Subject ▶ Change on Spring Holder and Pin8.

For Models ▶ LSI040

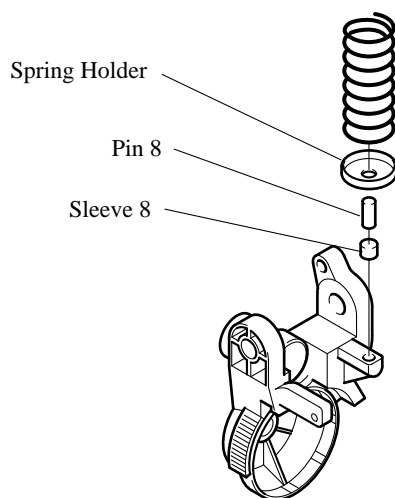
▶ Current	▶ New
Spring Holder		
Pin 8	all countries except U.S.A.,Canada and Mexico [Pin 8]	 [Pin 8]
	U.S.A.,Canada and Mexico [Pin 8] [Sleeve 8]

Current part		Q'ty	I/C	New part		Q'ty	Note
Pin 8 256260-4		1	No	Pin 8 256280-8		1	Interchangeable as a set (All countries except U.S.A., Canada and Mexico)
Spring Holder 343638-1		1	No	Spring Holder 344464-1		1	
Pin 8 256199-1		1	No	Pin 8 256280-8		1	Interchangeable as a set (U.S.A.,Canada and Mexico)
Sleeve 8 257681-3		1					
Spring Holder 343638-1		1	No	Spring Holder 344464-1		1
